Accessibility Survey

City of Downey Stamps Avenue - Downey Avenue to Gallatin Road

Stamps Avenue - Downey Avenue to Gallatin Road

City of Downey Stamps Avenue - Gainford Street to Suva Street

Change in Level North of Gainford Street @ 33.954135586810, -118.122559189796

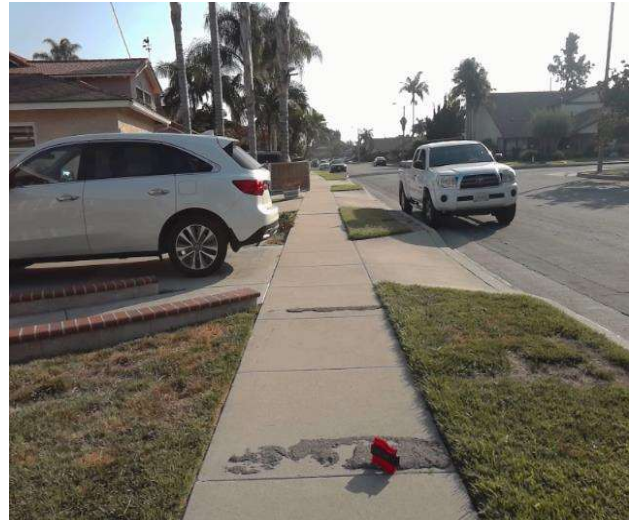
There is a change in elevation greater than recommended value.

On-Site Finding 0.50 inches

Ensure that the change in elevation is within the recommended value.

Recommendation Up to 0.25 inches

Sidewalk North of Gainford Street @ 33.953879728449, -118.122733533382

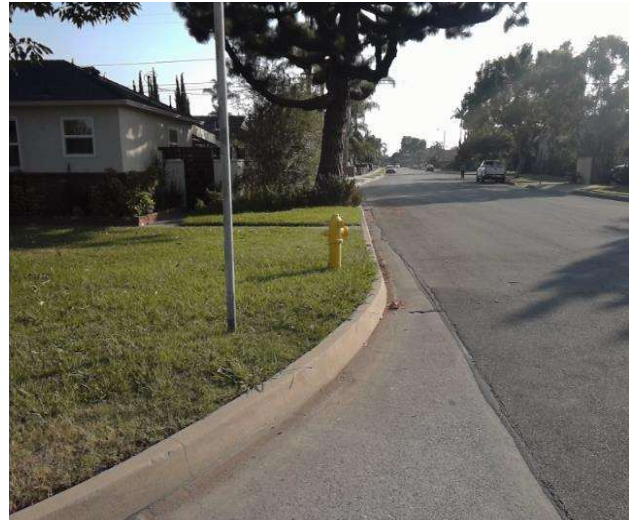
Section of sidewalk is missing and consists of dirt, grass or gravel.

On-Site Finding 93.00 feet

Provide a compliant sidewalk for the missing section.

Change in Level South of Vista Del Rio @ 33.958867715344, -118.118325322866

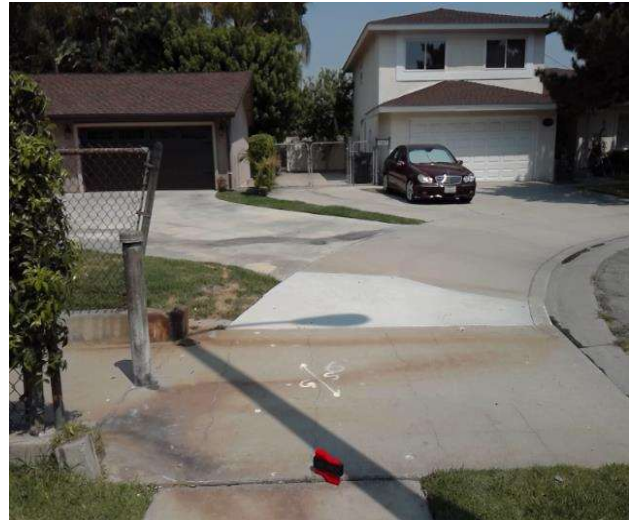
There is a change in elevation greater than recommended value.

On-Site Finding 0.87 inches

Ensure that the change in elevation is within the recommended value.

Recommendation Up to 0.25 inches

Change in Level North of Cul-De-Sac @ 33.959011210193, -118.118248879910

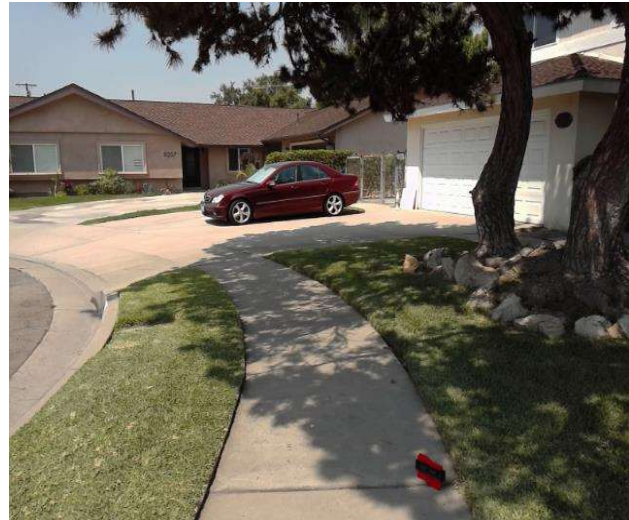
There is a change in elevation greater than recommended value.

On-Site Finding 0.62 inches

Ensure that the change in elevation is within the recommended value.

Change in Level North of Cul-De-Sac @ 33.959459490994, -118.117456287146

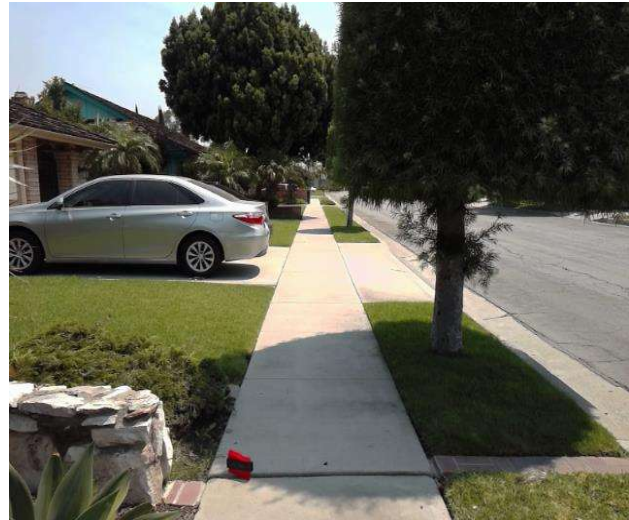
There is a change in elevation greater than recommended value.

On-Site Finding 0.75 inches

Ensure that the change in elevation is within the recommended value.

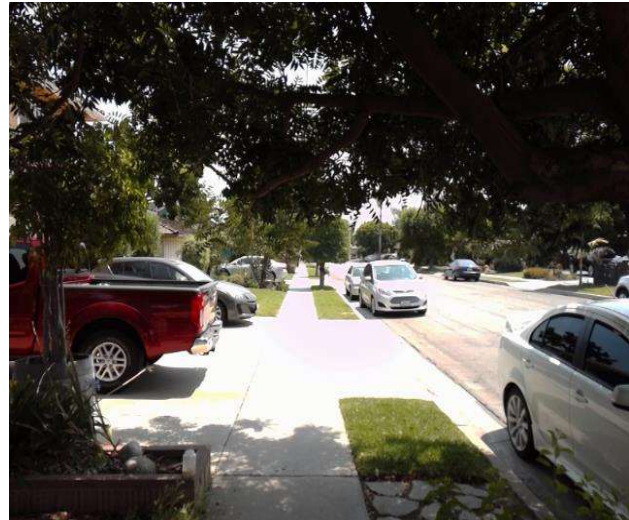
Overhead obstruction height is not compliant.

On-Site Finding 66.00 inches

Provide a compliant vertical clearance height.

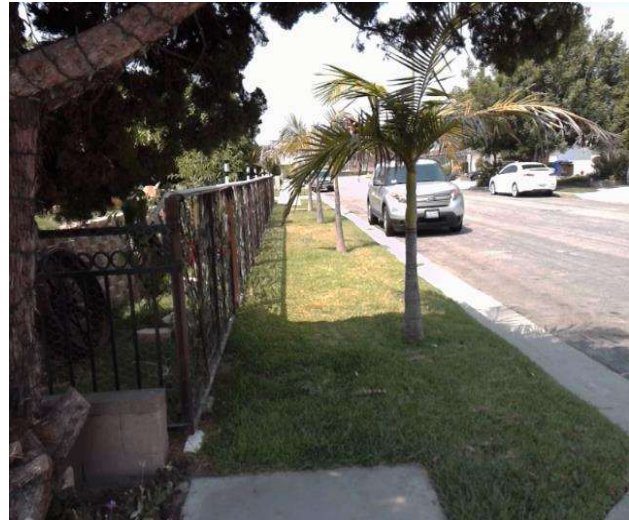
Section of sidewalk is missing and consists of dirt, grass or gravel.

On-Site Finding 72.00 feet

Provide a compliant sidewalk for the missing section.

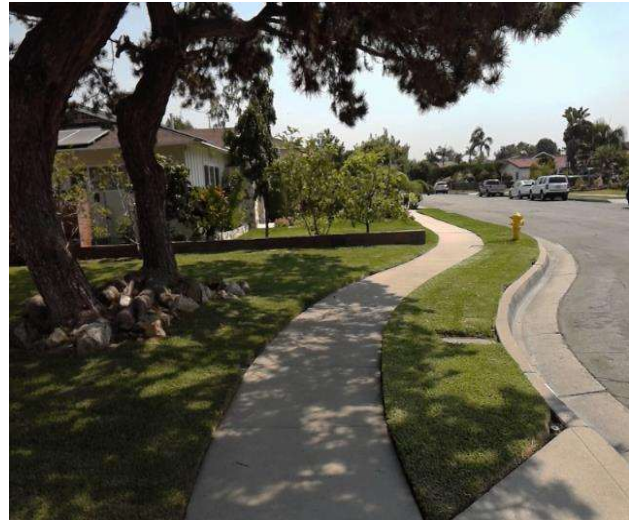
Sidewalk cross slope is not compliant.

On-Site Finding 4.30 percent for 21.00 feet

Repave the sidewalk surface with the recommended cross slope.
